MACARTHUR PLACE SUBDIVISION, **RESUBDIVISION OF LOT 9**

APPLICATION NUMBER 11 DATE May 19, 2011

DETAIL SITE PLAN

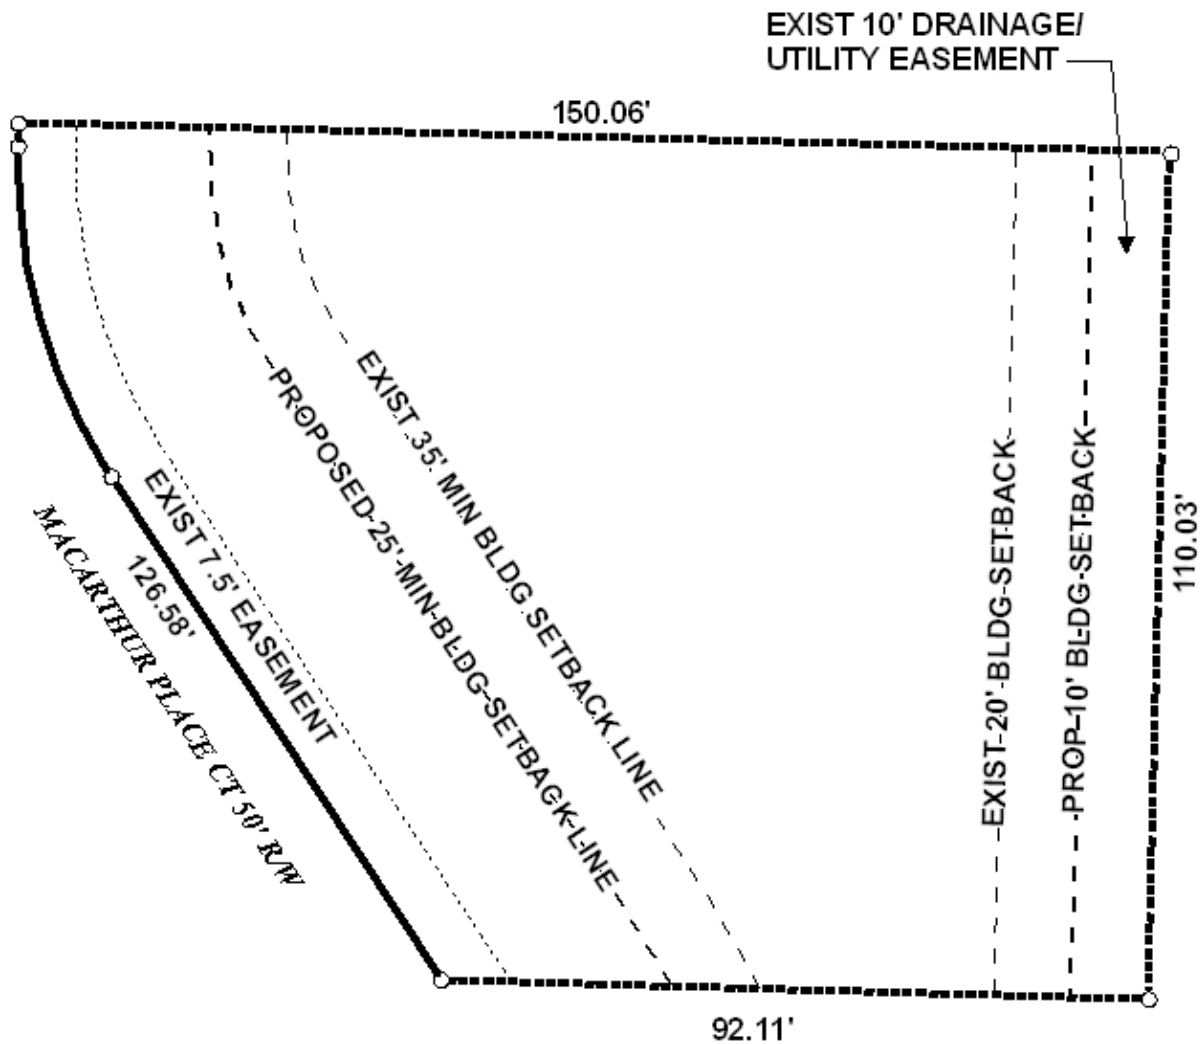
The plat illustrates the proposed 1 lot, 0.3 acre \pm subdivision which is located at 1225 Macarthur Place Court (East side of Macarthur Place Court, 500' \pm North of Grelot Road), and is in Council District 6. The applicant states that the subdivision is served by both public water and sanitary sewer.

The proposed lot, as depicted, meets the minimum size and frontage requirements as regulated by the Subdivision Regulations. The lot area size is depicted on the plat in square feet, and this should be retained on the Final Plat, if approved.

The site fronts Macarthur Place Court, a minor street provided with curb and gutter, to the East. The plat depicts an adequate 50-foot right-of-way, and no further dedication should be required. Should the application be approved, the lot should be limited to one curb cut, with the size, design, and exact location of all curb cuts to be approved by Traffic Engineering and conform to AASHTO standards.

The lot currently has a minimum building setback line of 35 feet, a rear setback of 20 feet, and side yard setbacks of 10 feet. The applicant wishes to reduce the minimum building setback line to 25 feet and the rear setback to 10 feet. The 25-foot minimum building setback complies with Section V.D.9. of the Subdivision Regulations and the 10-foot rear yard setback complies with the Zoning Ordinance.

As this request would modify the setbacks of a single lot in a 19-lot subdivision where the majority of the lots have been developed, it would seem that the request does not comply with the aforementioned Section. Additionally, the applicant did not provide any justification for the reduced setbacks.

- 1) the proposed setbacks do not comply with Section V.D.1. of the Subdivision Regulations regarding compatibility and appropriateness to location.

Based upon the preceding, this application is recommended for denial for the following reasons:
